Customer : CU-DAR001 Dart Helicopters Services Drawing Name : HELI UTILITY BASKET LH/RH 350/355
 Job Number : 36414
 Estimate Number : 10208
 P.O. Number : *N/A* Part Number : D350607043
 This Issue : 12/18/2007 S.O. No. : *N/A* Drawing Number : D350-607 REV F P7-9
 Prsht Rev. : NC Project Number : *N/A*
 First Issue : *NA* Type : LARGE FAB ASSY Drawing Revision : F
 Previous Run : 36413 Material : *N/A*
 Due Date : 1/25/2008 Qty: 1 Um: Each
 Written By : *[Signature]*
 Checked & Approved By : *[Signature]*
 Comment : Est Rev:E as Per DSI9318 06-01-24 JLM

DESIGN <i>CP</i>	DRAWN BY <i>CP</i>	DART AEROSPACE LTD HAWKESBURY, ONTARIO, CANADA	
CHECKED <i>[Signature]</i>	APPROVED <i>[Signature]</i>	DRAWING NO. DSI 9318	REV. - A SHEET 1 OF 1
DATE 06.01.06		TITLE WASHER ADDITION	SCALE NTS
A	06.01.06	NEW ISSUE

DART SERVICE INSTRUCTION

TO AMEND INSTALLATION INSTRUCTIONS D350-607 REV. F

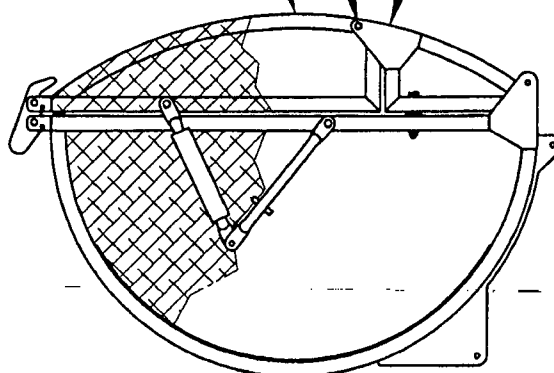
To reduce the possibility of damaging the finish, a **NAS1515H4** washer (2 places) has been added between the hinge plate and basket frame on the **D350-607-043/-047 Heli-Utility-Basket**.

The corrected bolt stackup from Figure 5 of installation instructions D350-607 Rev. F is given below:

AN4-13A BOLT (1)
AN960JD416 WASHER (1)
HINGE PLATE (REF)
NAS1515H4 WASHER (1)
BASKET FRAME (REF)
AN960JD416 WASHER (1)
MS21042L4 NUT (1)
(2 PLACES)
